5. Revised DEIS Comments and Responses

This section contains all comments and responses made on the Revised DEIS received by WSDOT during the comment period. The comments and responses are grouped in the following order: federal and state agencies (A), local jurisdictions and representatives (L), comment forms (C), and public hearings (CRO, CRH).

This letter provides the comments of the U.S. Department of the Interior (Department) on the Revised Draft Environmental Impact Statement (RDEIS) and Draft Section 4(f) Evaluation for the proposed SR 509 Corridor Completion/I-5/South Access Road. This project will complete a major north south corridor in a metropolitan area where the existing highway system is inadequate. The present configuration of roads, airport, and essential development and protection zones put significant constraints on locating new highways and appropriate interchanges, as do the natural features such as streams, wetlands, ravines, and the wildlife that inhabit this green space.

Chart 2, Page 3 of 4

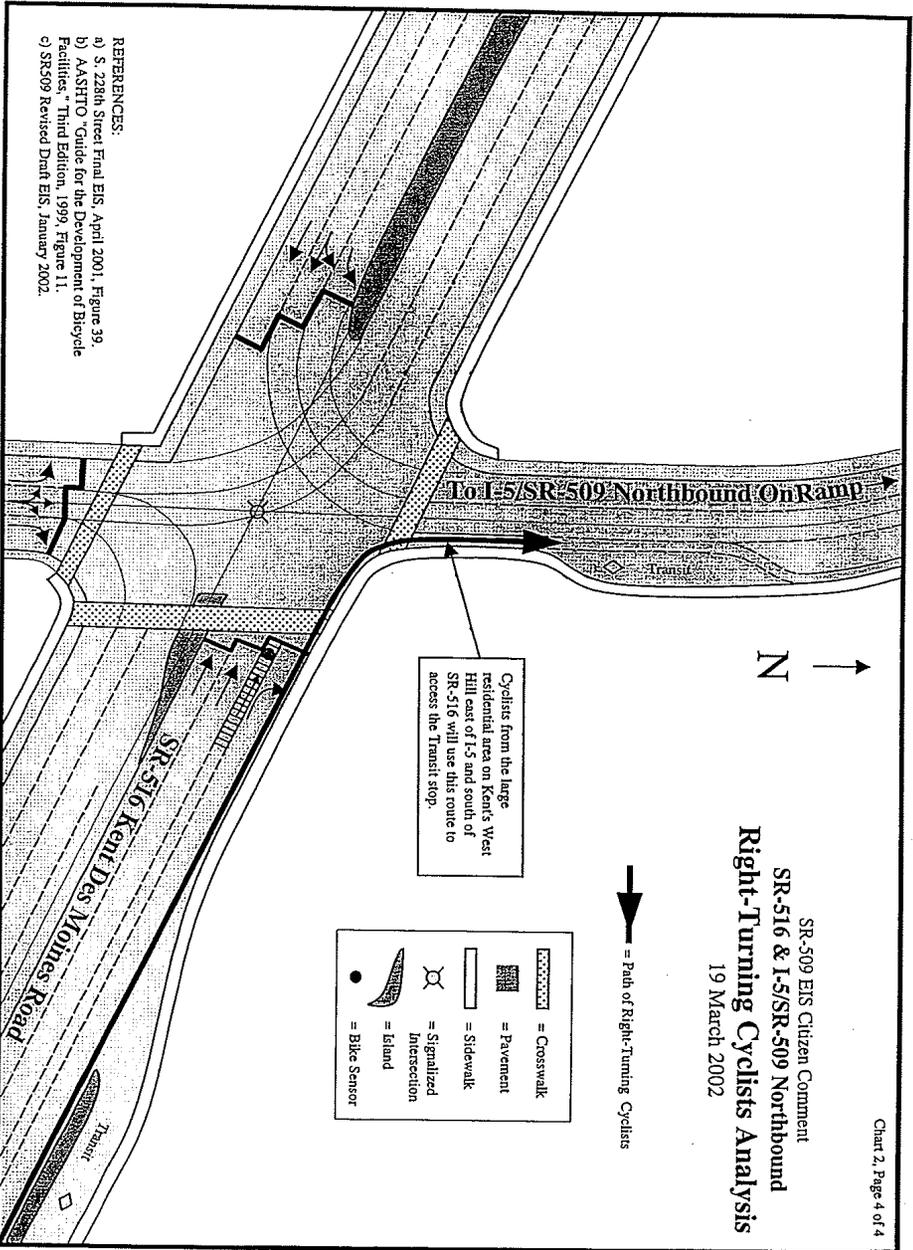
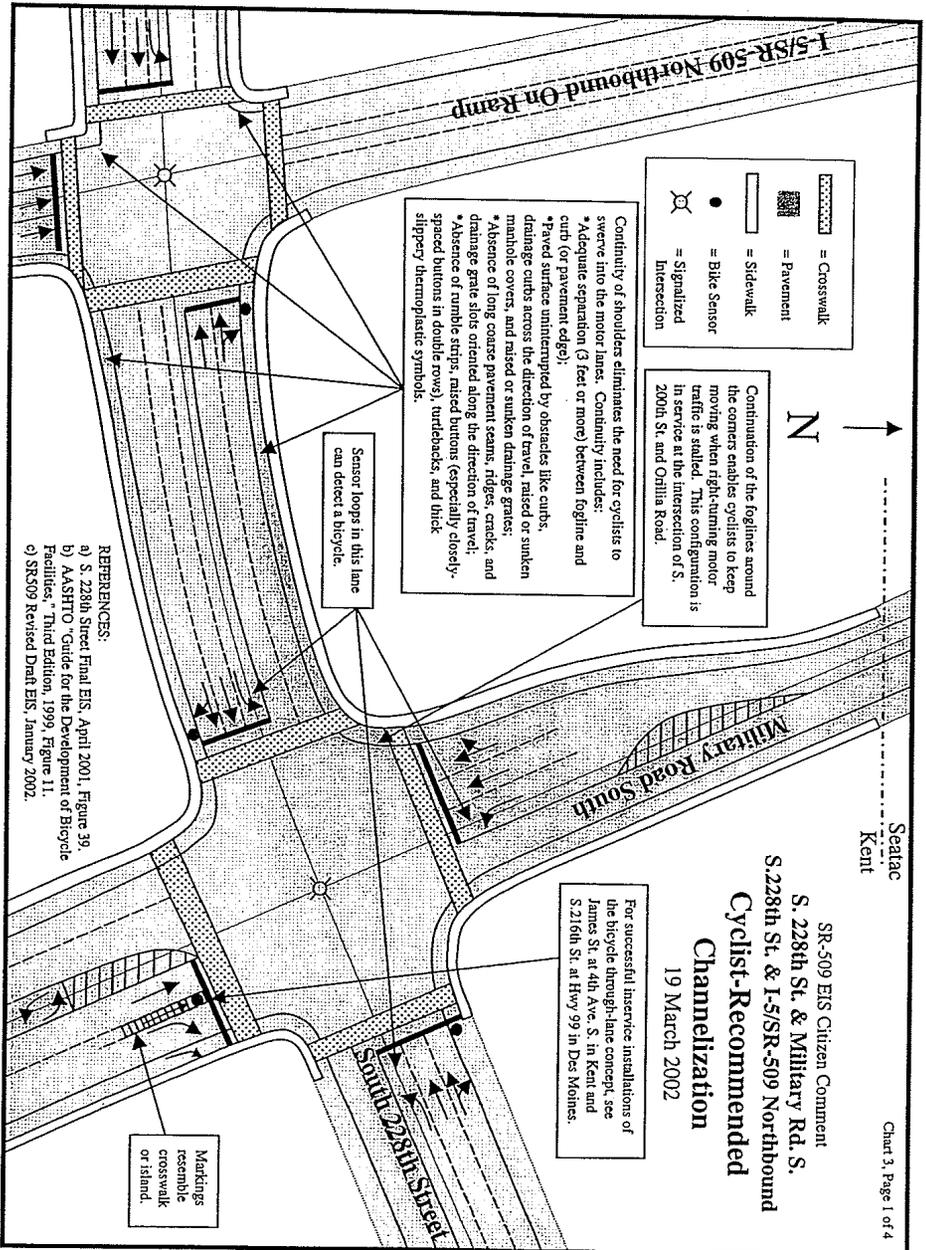
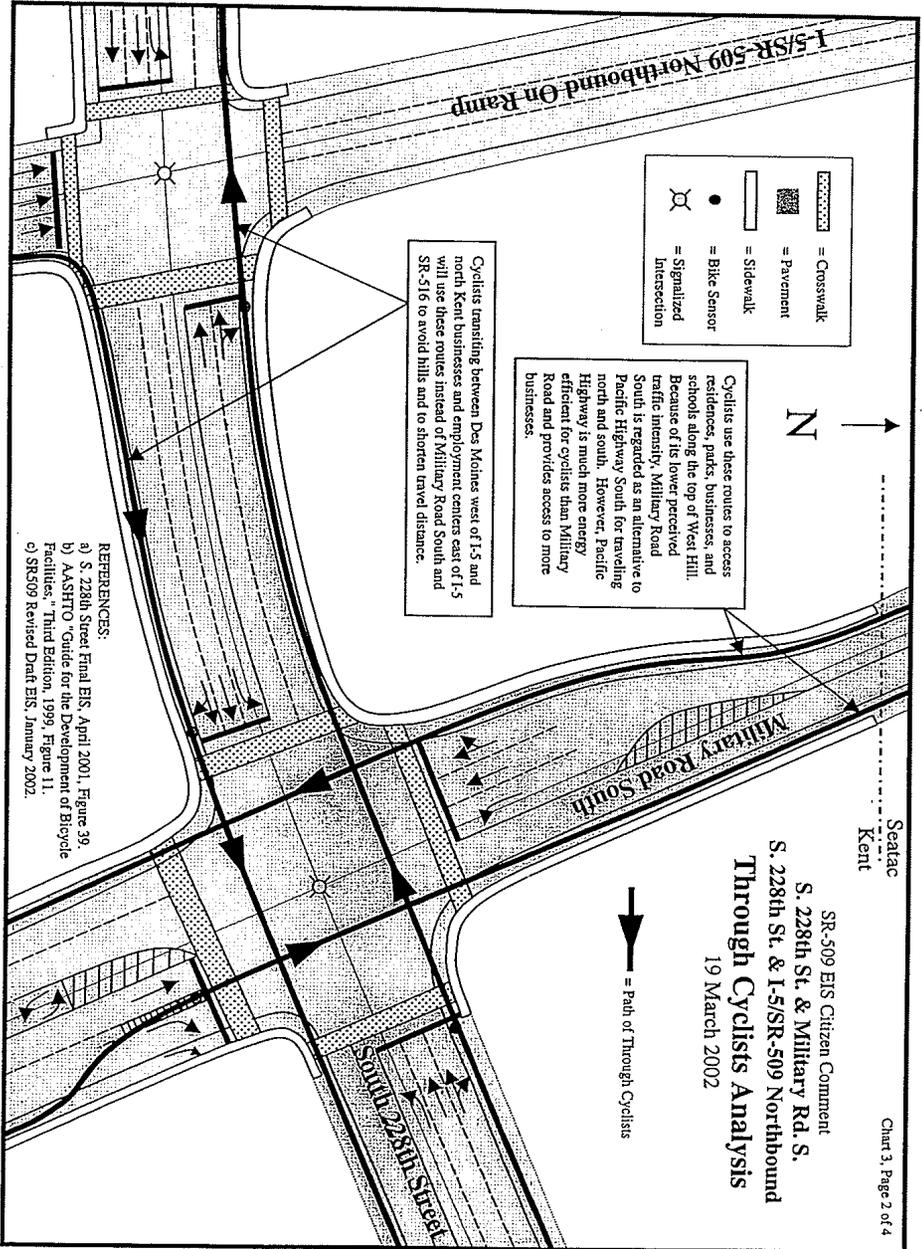
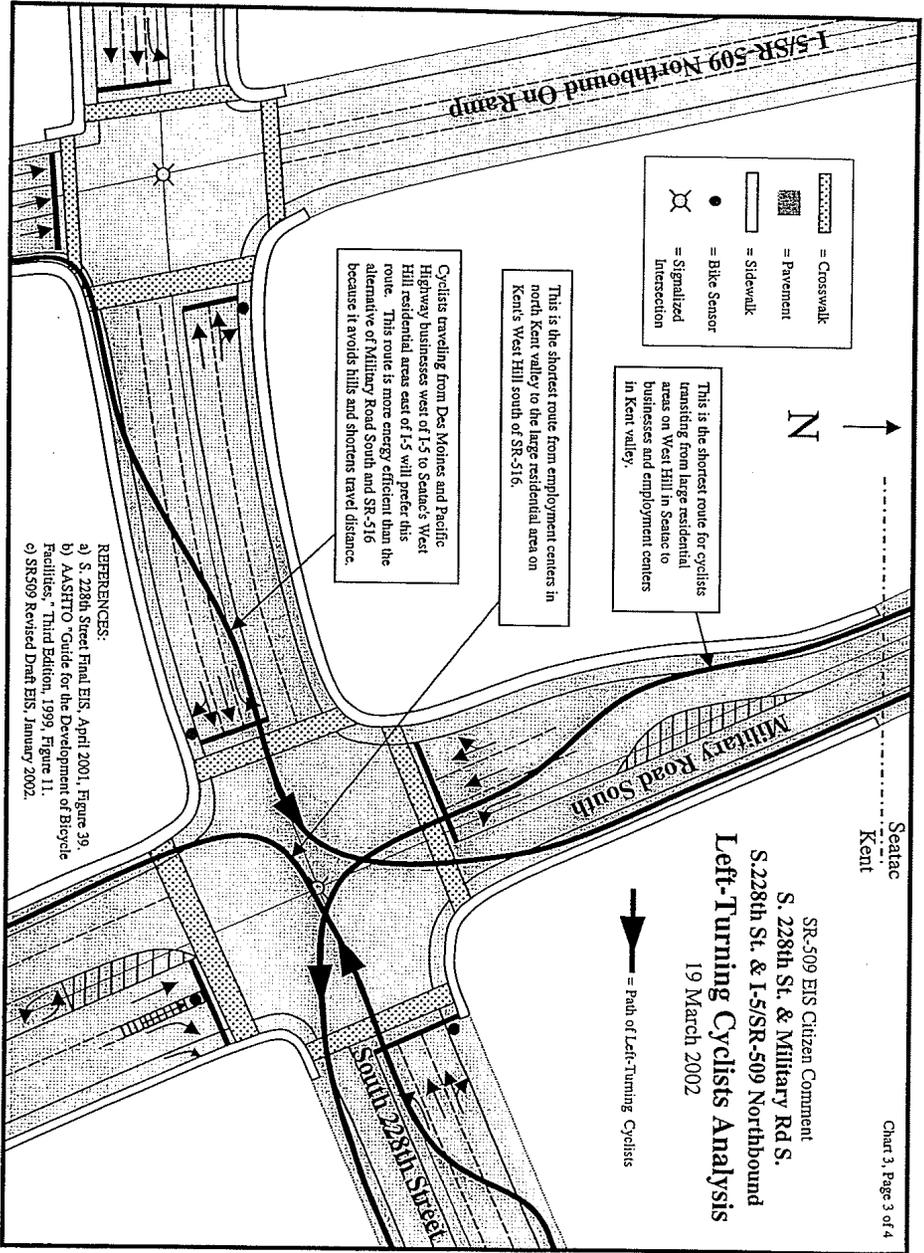
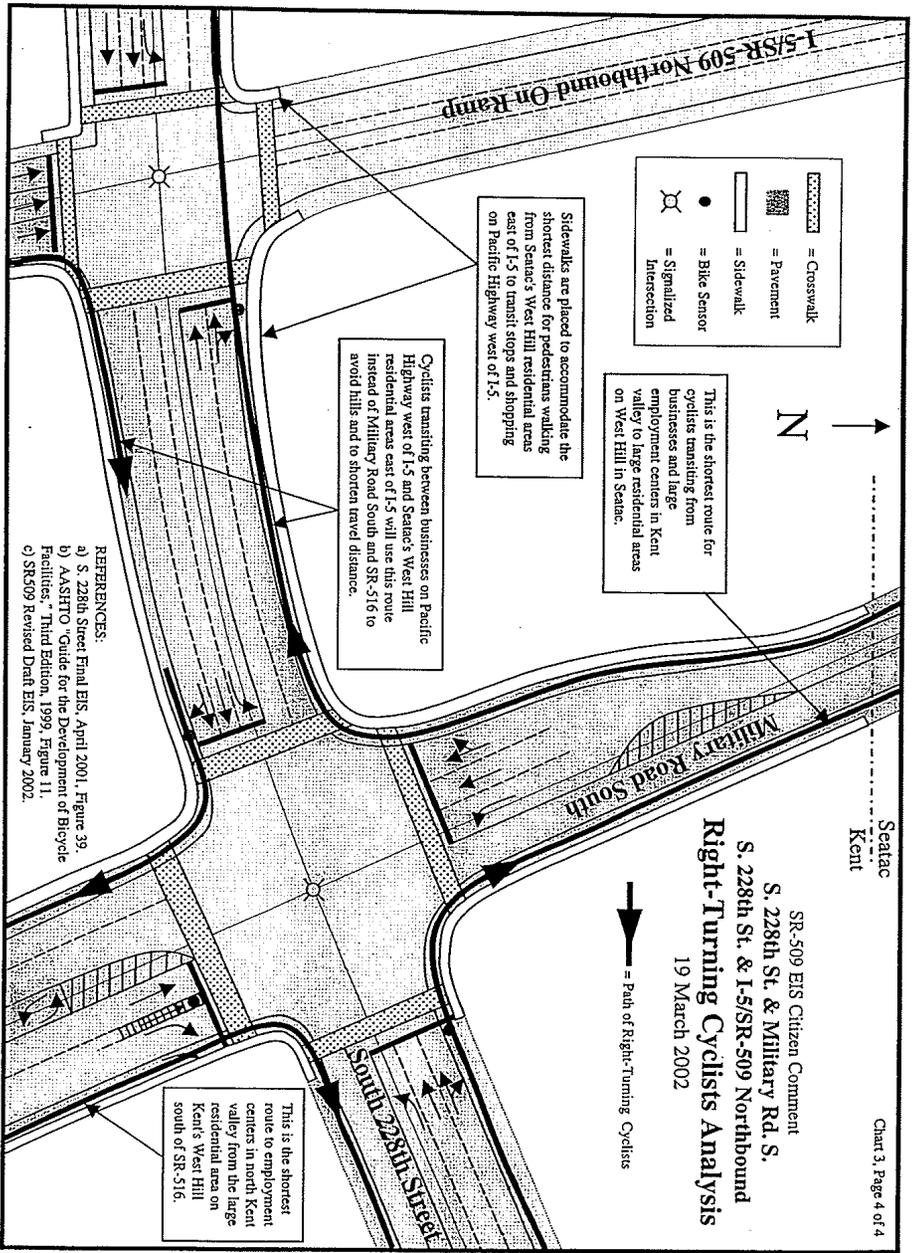
- REFERENCES:**
- a) S. 228th Street Final EIS, April 2001, Figure 39
 - b) AASHTO "Guide for the Development of Bicycle Facilities," Third Edition, 1999, Figure 11.
 - c) SR509 Revised Draft EIS, January 2002.

Thank you for the time and effort in providing detailed suggestions for bicycle intersection improvements. Improvements to some of the eight intersection identified in your comments are not part of the proposed project. Your suggested intersection improvements have been forwarded to the Cities of Kent and Des Moines. We will continue to work with the bicycle community as we develop the preliminary design of the facilities associated with the proposed project, and will make those designs available for review when they are sufficiently complete.

Chart 4 Page 1 of 2

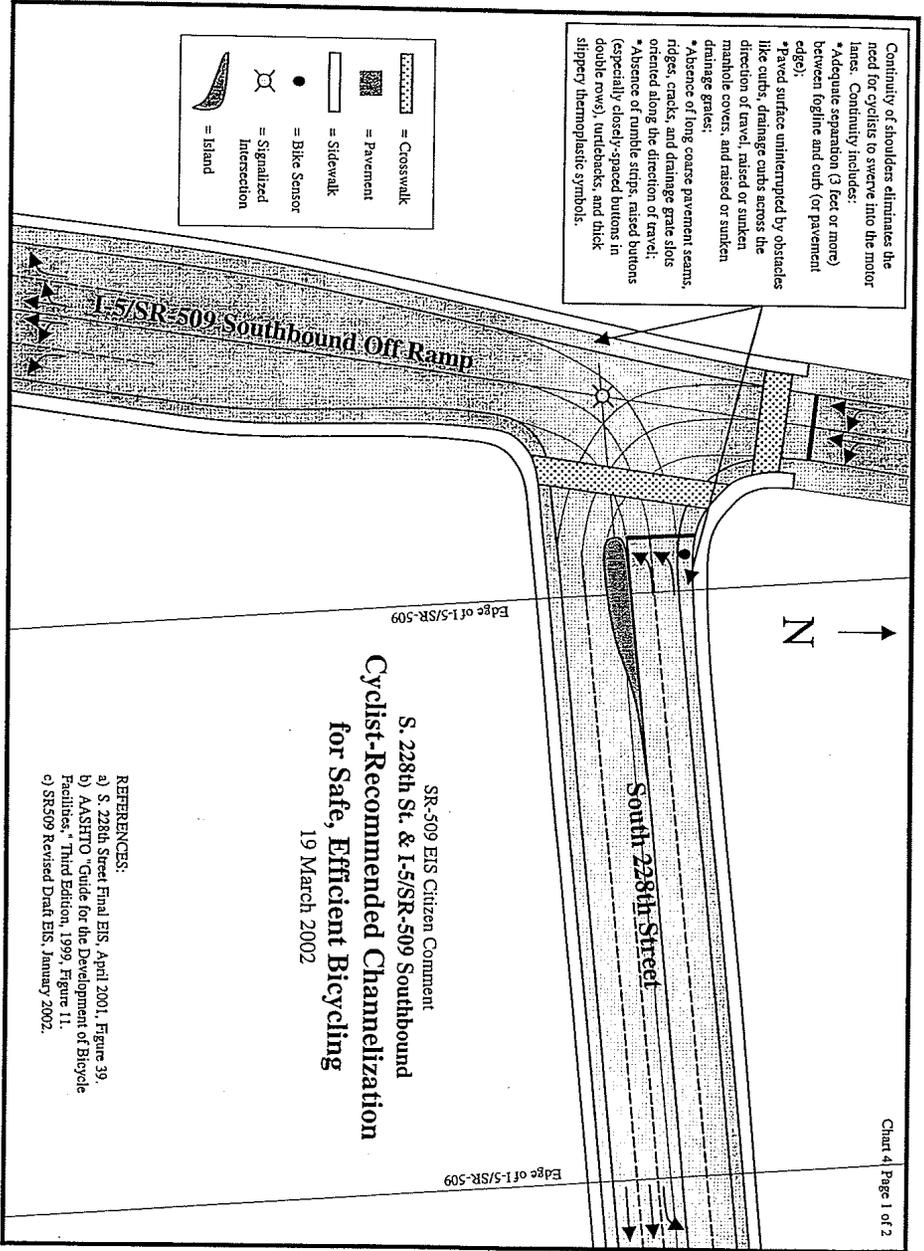
Continuity of shoulders eliminates the need for cyclists to swerve into the motor lanes. Continuity includes:

- *Adequate separation (3 feet or more) between fogline and curb (or pavement edge).
- *Paved surface uninterrupted by obstacles like curbs, drainage cuts across the direction of travel, raised or sunken manhole covers, and raised or sunken drainage grates.
- *Absence of long course pavement seams, ridges, cracks, and drainage grate slots oriented along the direction of travel.
- *Absence of rumble strips, raised buttons (especially closely-spaced buttons in double rows), turtles/bumps, and thick slippery thermoplastic symbols.

SR-509 EIS Citizen Comment
 S. 228th St. & I-5/SR-509 Southbound
**Cyclist-Recommended Channelization
 for Safe, Efficient Bicycling**
 19 March 2002

Chart 4 Page 2 of 2

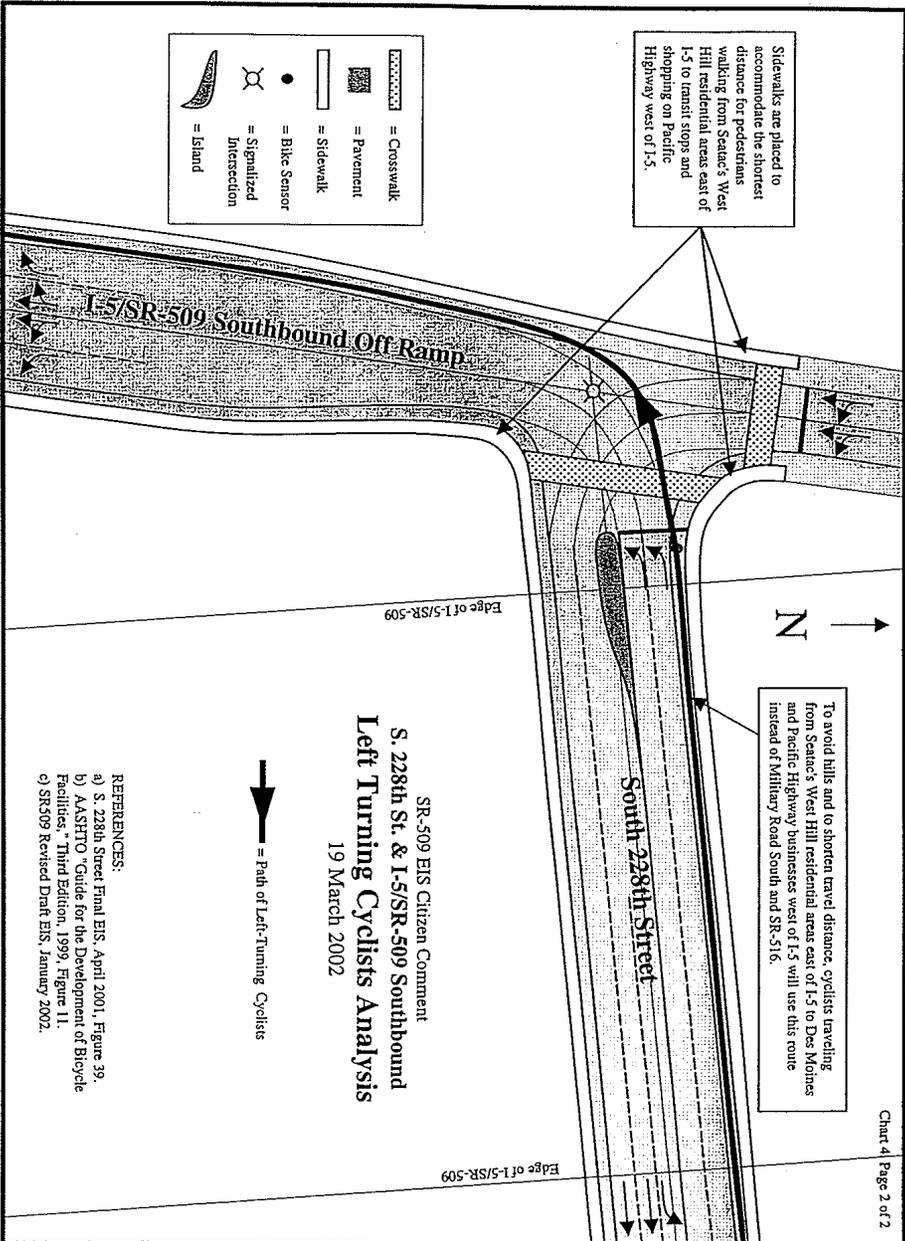
SR-509 EIS Citizen Comment
S. 228th St. & I-5/SR-509 Southbound
Left Turning Cyclists Analysis
 19 March 2002

Chart 5, Page 4 of 4

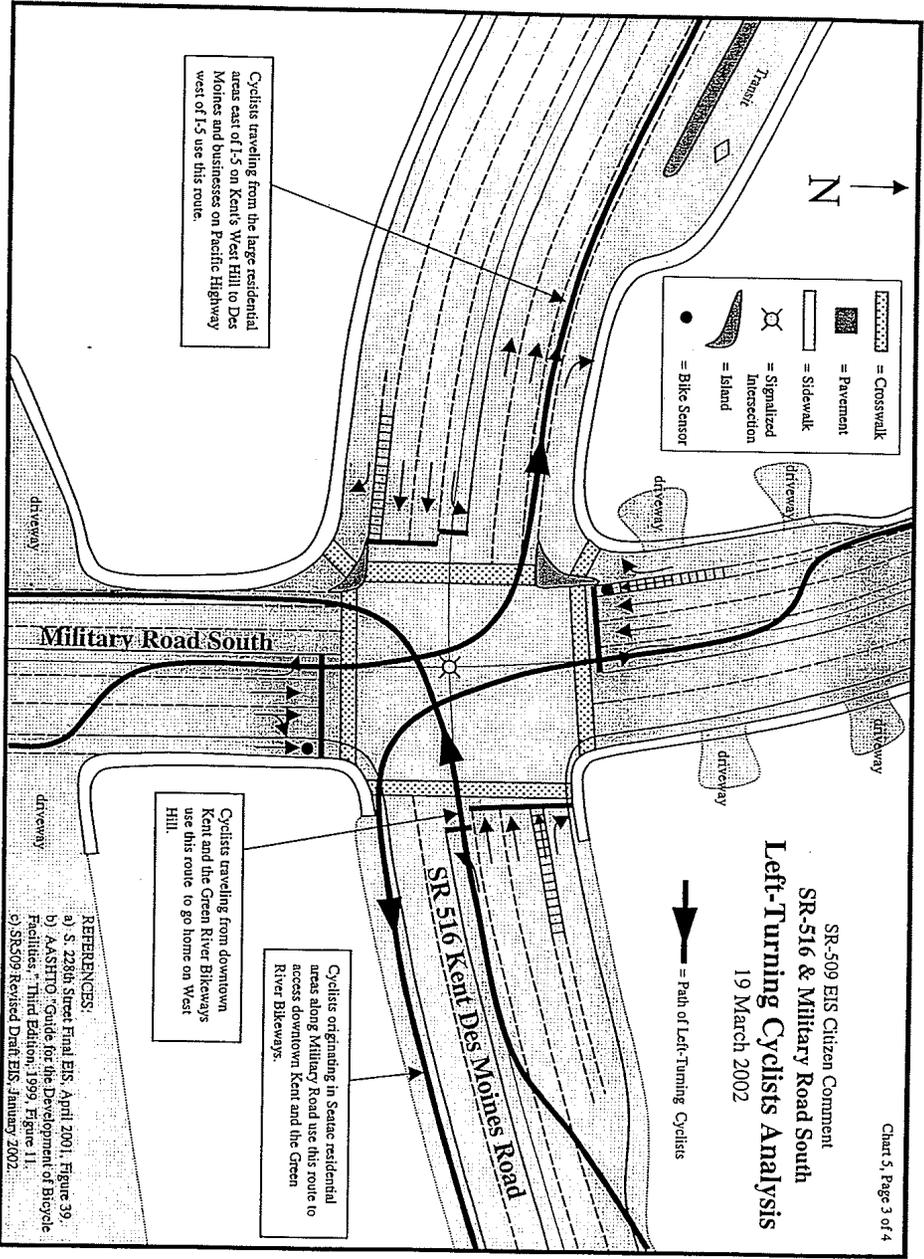
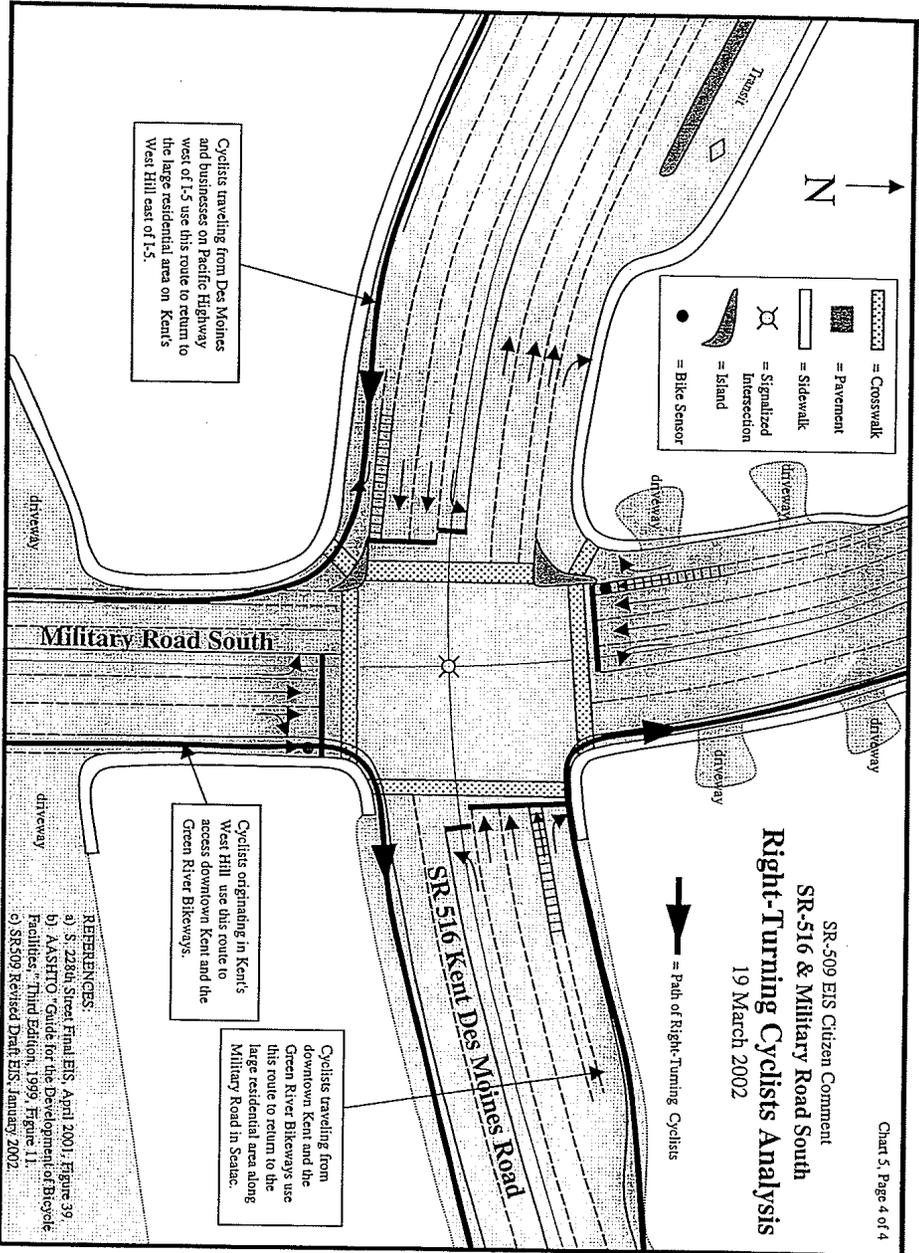
SR-509 EIS Citizen Comment
 SR-516 & Military Road South
 Right-Turning Cyclists Analysis
 19 March 2002
